SUBJECT: CLINTON POWER STATION, UNIT 1 - ISSUANCE OF AMENDMENT
(TAC NO. MA9862)

The amendment revises the Technical Specification reactor vessel pressure-temperature limits.

AMENDMENT TO FACILITY OPERATING LICENSE

SAFETY EVALUATION BY THE OFFICE OF NUCLEAR REACTOR REGULATION
RELATED TO AMENDMENT NO. 134 TO FACILITY OPERATING LICENSE NO. NPF-62

Figure 3.4.11-1
Bottom Head and RCS Composite P/T Curves
for Pressure Tests [Curve A] up to 32 EFPY

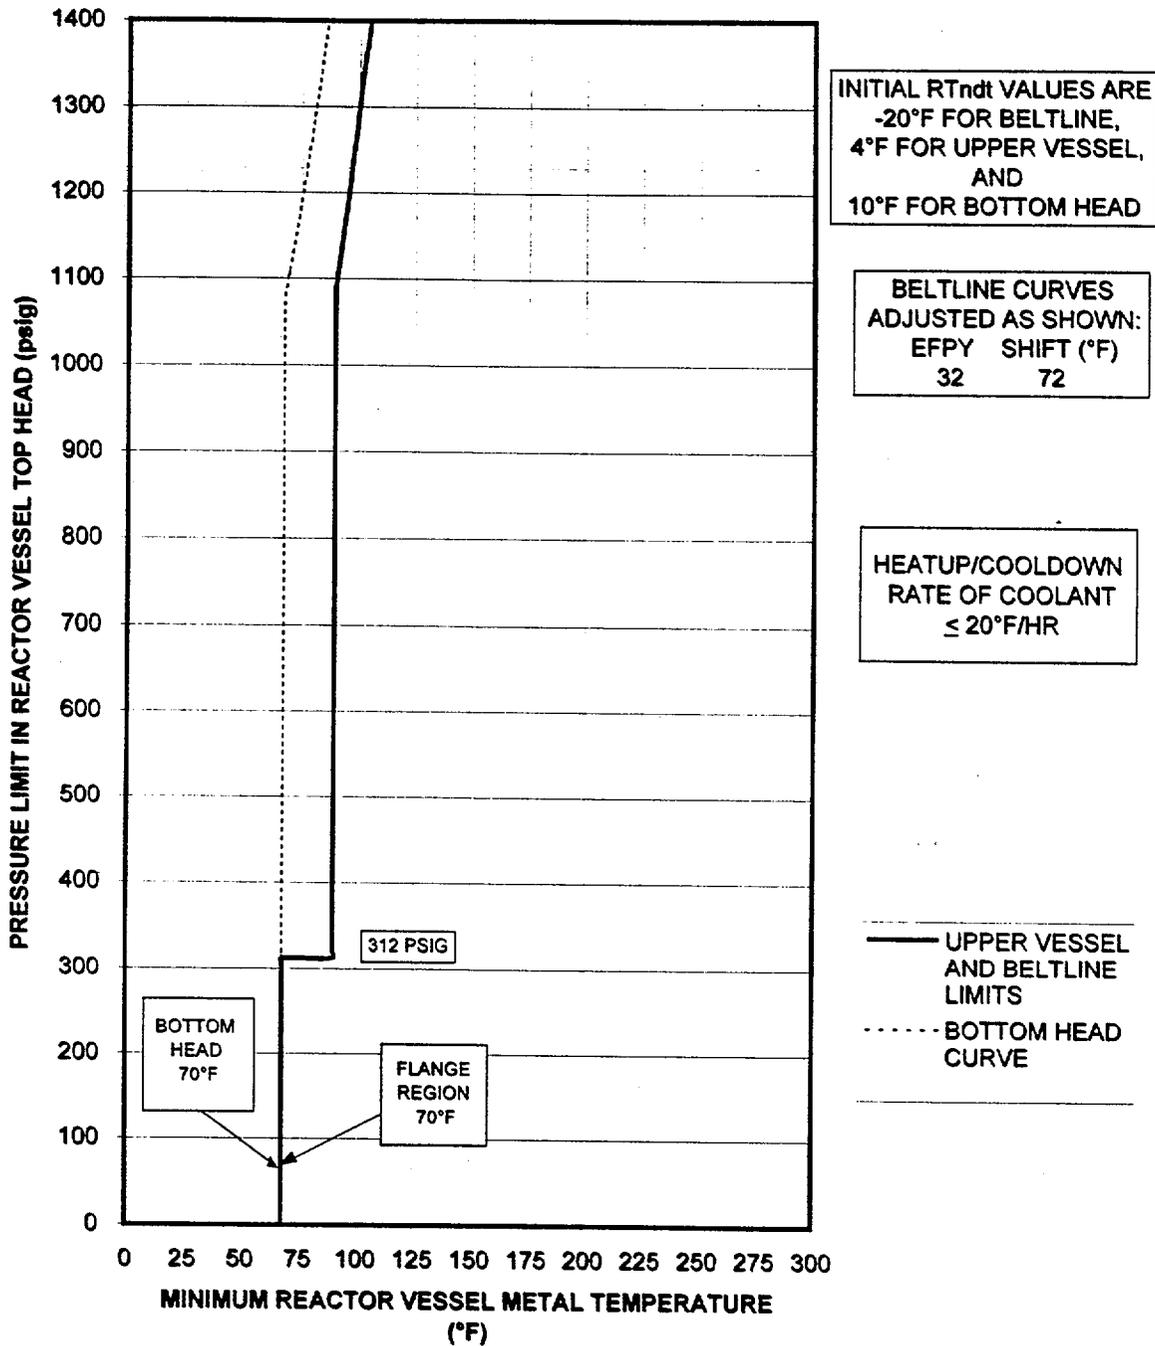
SURVEILLANCE	FREQUENCY
<p>SR 3.4.11.1 -----NOTE----- Only required to be performed during RCS heatup and cooldown operations and RCS inservice leak and hydrostatic testing. ----- Verify: a. RCS pressure and RCS temperature are within the limits of Figures 3.4.11-1, 3.4.11-2 and 3.4.11-3; and b. RCS heatup and cooldown rates are as indicated on the figures.</p>	<p>30 minutes</p>

For the CPS RPV, the licensee provided the P-T limit curves for normal operating conditions and pressure testing conditions effective to 22 EFPY and 32 EFPY. For normal operating conditions with the core not critical and for pressure testing conditions, individual P-T curves were proposed for lower head in addition to the composite curves proposed for the beltline and nozzle regions of the RPV. To test the validity of the licensee's proposed curves, the staff performed an independent assessment of the licensee's submittal. The staff applied the methodologies of 1995 Edition of Appendix G to the Code and 10 CFR Part 50, Appendix G, as modified by the methodologies of ASME Code Cases N-588 and N-640, as the basis for its independent assessment. For the evaluation of the RPV nozzles, the staff also modified the methods of Appendix G to the Code by the nozzle evaluation methods proposed in Appendix 5 of Welding Research Council Bulletin WRC-175, "PVRC Recommendations on Toughness Requirements for Ferritic Materials" (August 1972).

Based on the staff's review and evaluation of the licensee's proposed P-T limit curves for CPS, the staff has determined that the proposed P-T limit curves are consistent with the alternate criteria of Code Cases N-588 and N-640, and satisfy the requirements of 10 CFR 50.60(a), "Acceptance Criteria for Fracture Prevention Measures for Lightwater Nuclear Power Reactors for Normal Operation;" Appendix G to 10 CFR Part 50, "Fracture Toughness Requirements;" and Appendix G to the 1995 Edition of Section XI of the ASME Code, as exempted by the methods of analyses in Code Cases N-588 and N-640. However, given the uncertainties in the 32 EFPY neutron fluence calculations for CPS, the staff concludes that the updated P-T limit curves proposed by the licensee will continue to provide an acceptable level of margin and safety, and provide sufficient assurance that the CPS reactor will be operated in a manner that will protect the RPV against brittle fracture through October 15, 2003. The proposed curves are therefore approved for incorporation into the CPS TS and for use through October 15, 2003. On September 21, 2000, the licensee informed the staff that the applicability of the proposed P-T limit curves would be limited to October 15, 2003.

Figure 3.4.11-3
RCS Composite P/T Curves for Core Critical
Operation [Curve C] up to 32 EFPY

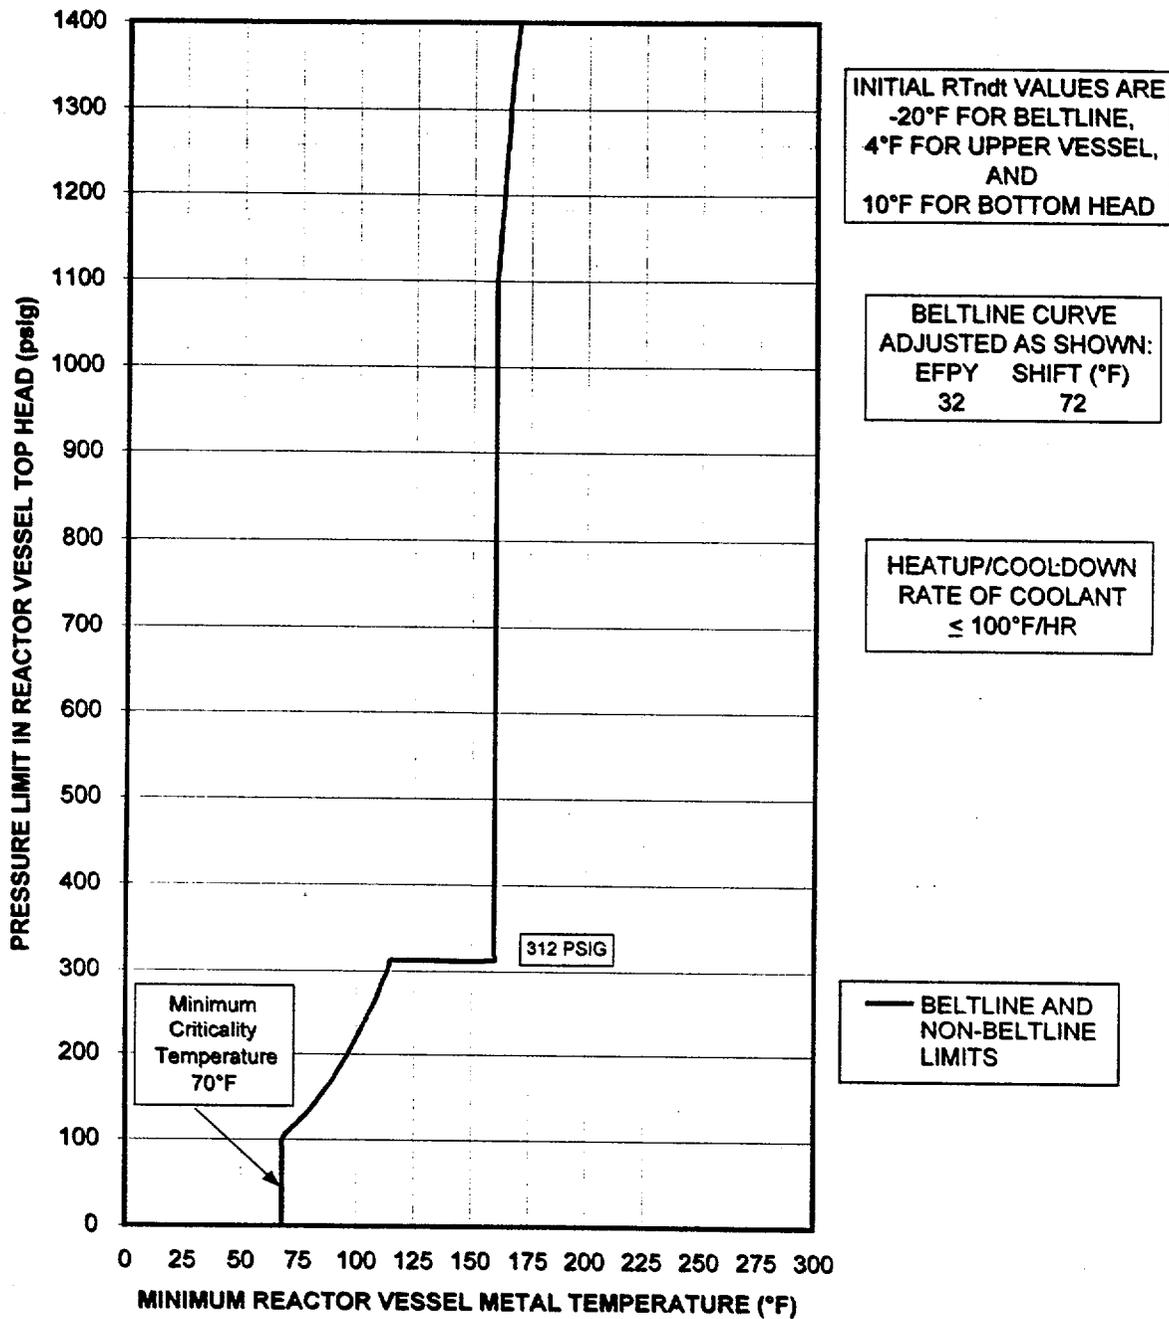
SURVEILLANCE	FREQUENCY
<p>SR 3.4.11.2 -----NOTE----- Only required to be met during control rod withdrawal for the purpose of achieving criticality. -----</p> <p>Verify RCS pressure and RCS temperature are within the criticality limits of Figure 3.4.11-3.</p>	<p>Once within 15 minutes prior to control rod withdrawal for the purpose of achieving criticality</p>
<p>SR 3.4.11.3 -----NOTE----- Only required to be met in MODES 1, 2, 3, and 4 during recirculation pump start. -----</p> <p>Verify the difference between the bottom head coolant temperature and the reactor pressure vessel (RPV) coolant temperature is $\leq 100^{\circ}\text{F}$.</p>	<p>Once within 15 minutes prior to each startup of a recirculation pump</p>
<p>SR 3.4.11.4 -----NOTE----- Only required to be met in MODES 1, 2, 3, and 4 during recirculation pump start. -----</p> <p>Verify the difference between the reactor coolant temperature in the recirculation loop to be started and the RPV coolant temperature is $\leq 50^{\circ}\text{F}$.</p>	<p>Once within 15 minutes prior to each startup of a recirculation pump</p>
